CITY OF ALBUQUERQUE

Re: Comfort Suites Hotel
1401 Woodward Ave SE
Request for Certificate of Occupancy
Transportation Development Final Inspection
Engineer's/Architect's Stamp dated 8-15-16 (DRB) (M15D023G)
Certification dated 1-26-21

Based upon the information provided in your submittal received 1-27-21, Transportation Development cannot approve the release of Certificate of Occupancy for the above referenced project.

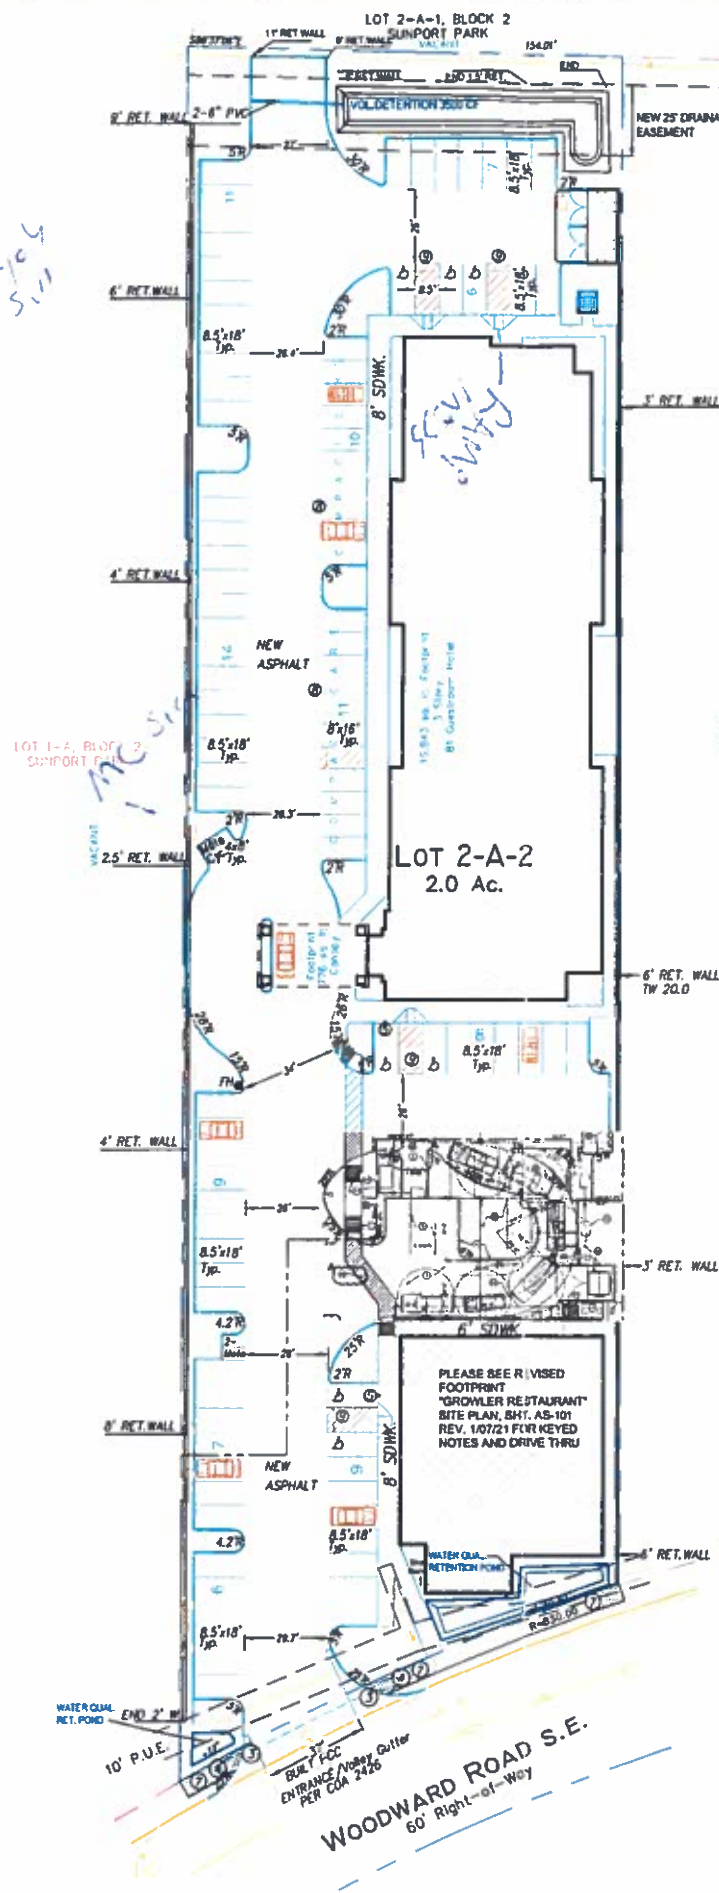
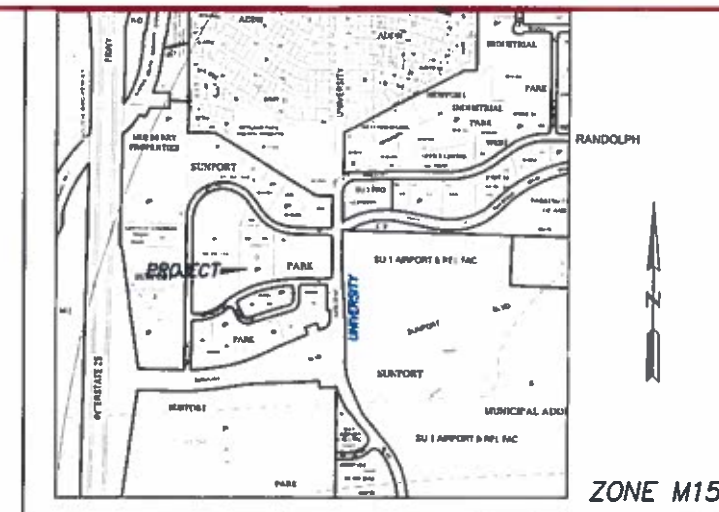
- Please add missing ADA ramp. (ADA Access Aisle in rear of property)
- Please add Motorcycle Signs

- Please remove construction equipment, debris, trailers, security fence and trash container from site.

1. The approved and stamped Site Plan for Building Permit with changes drawn in red.
2. Transportation Certification letter on either the plan or applicants letterhead.
3. A Drainage Transportation Information Sheet (DTIS)
4. Send an electronic copy of your submittal to PLNDRS@cabq.gov.
5. The \$75 re-submittal fee for log in and evaluation by Transportation.
